Re: BusConnects Belfield/Blackrock to City Centre Core Bus Corridor Scheme

RE: SUBMISSION ON BEHALF OF THE DAVY PLATFORM ICAV ACTING ON BEHALF OF ITS SUB FUND ELM REAL ESTATE INVESTMENTS REGARDING BUSCONNECTS BELFIELD/BLACKROCK TO CITY CENTRE CORE BUS CORRIDOR SCHEME PLANNING APPLICATION (ABP-313509-22) AND COMPULSORY PURCHASE ORDER AT ELMPARK GREEN (PLOT LIST: 1042(1).1E) (ABP-313565-22)

Figure 1: Extract of Proposed BusConnects Layout Highlighted Section of Land Requested to be Subject to Temporary CPO Only

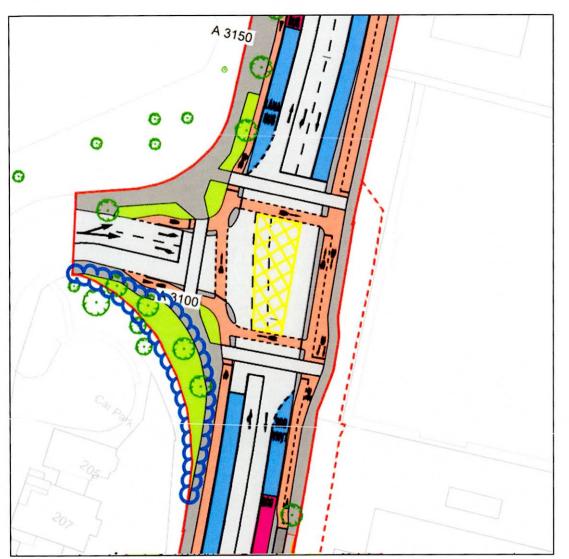
In this regard, our original submission ultimately noted that the specific request in our original submission focussed on the portion of proposed landscape area to the southeast of the junction and requested that this be subject to a temporary CPO only. This will facilitate construction works as required but revert back to part of the Elmpark Green Development once complete. For clarity, this area is indicatively highlighted by the blue cloud on the BusConnects General Arrangement Layout following.

Figure 2: Extract from Proposed Traffic Signal Design Layout
(BCIDC-ARP-TSM SJ-1415 XX 00-DR-TR-0012)

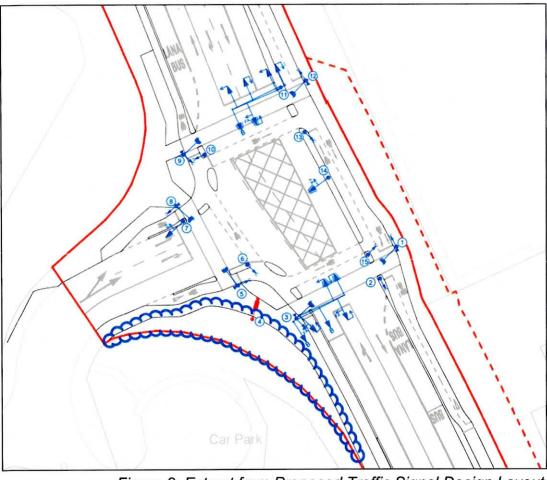
As can be seen, the area in question is almost entirely free of proposed traffic signal infrastructure with the exception of a single CCTV pole and camera which is located immediately adjacent the back of footpath which would easily be accommodated without need to permanently CPO the entire area highlighted.

Induction loops are not shown but would be located in the carriageway exclusively while ducting would be expected to be confined to the footpaths so

as not to conflict with proposed planting in the landscaped area. The existing junction traffic controller is located on the northwest side of the junction and away from the landscaped area in question.

On this basis, it is considered that only a very minor area of permanent CPO is required in the landscaped area highlighted to facilitate traffic infrastructure and the remainder could reasonably revert to the ownership of the Elmpark Green Development once construction works are complete.

<u>Figure 3: Extract from Proposed Surface Water and SUDS Design Layout</u>
(BCIDC-ARP-DNG RD-1415 XX 00-DR-CD-0009)

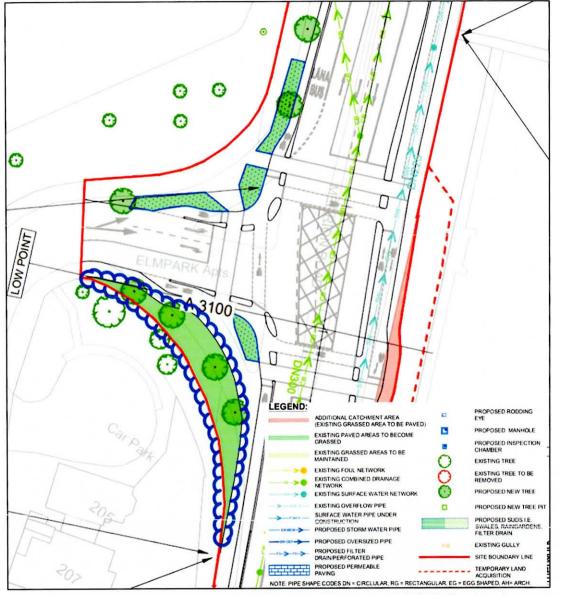
As can be seen above, there is no proposed surface water or SUDS infrastructure proposed in the landscaped area in question.

On this basis, it is considered that no permanent CPO of this area is required to facilitate surface water infrastructure.

Figure 4: Extract from Proposed Public Lighting Design Layout (BCIDC-ARP-LHT RL-1415 XX 00-DR-EO-0009)

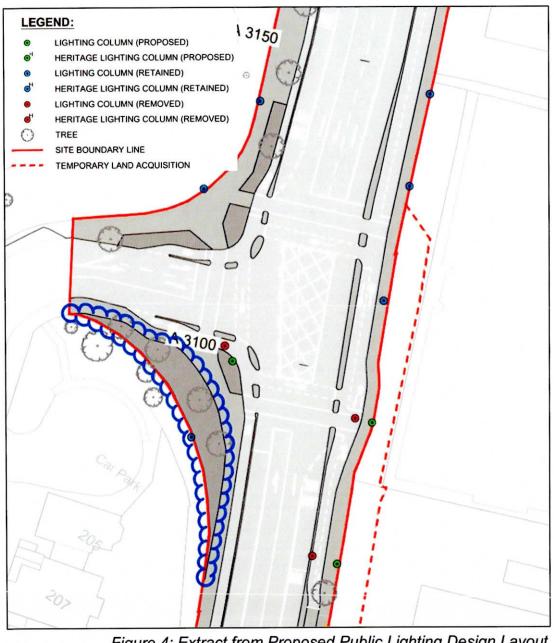
The drawing notes that only a single public lighting is proposed in the landscape area in question. This is an existing column which is to be retained

in its current position, at the back of existing footpath. The drawing also notes that "lighting column locations are indicative".

As can be seen, all other lighting columns are to be located at updated back of footpath locations which is the standard to ensure appropriate effectiveness and ease of access for maintenance. It is considered extremely unlikely that the lighting column indicated in this landscaped area, remote from the footpath and road it is to light, will ultimately be constructed in this location. Instead, it is expected to be more appropriately moved to the revised back of footpath proposed. This can again be easily accommodated in a similar manner to that suggested for the proposed CCTV camera in this area without the need for the permanent CPO of the entirety of this portion of the lands.

On this basis, having considered the proposed design information submitted as part of this application, it is again requested that the landscaped area to the southwest of the junction be subject to a temporary CPO order only to facilitate construction and that the permanent extent of CPO lands be limited to areas where permanent infrastructure is indicated and realistically expected to be located.
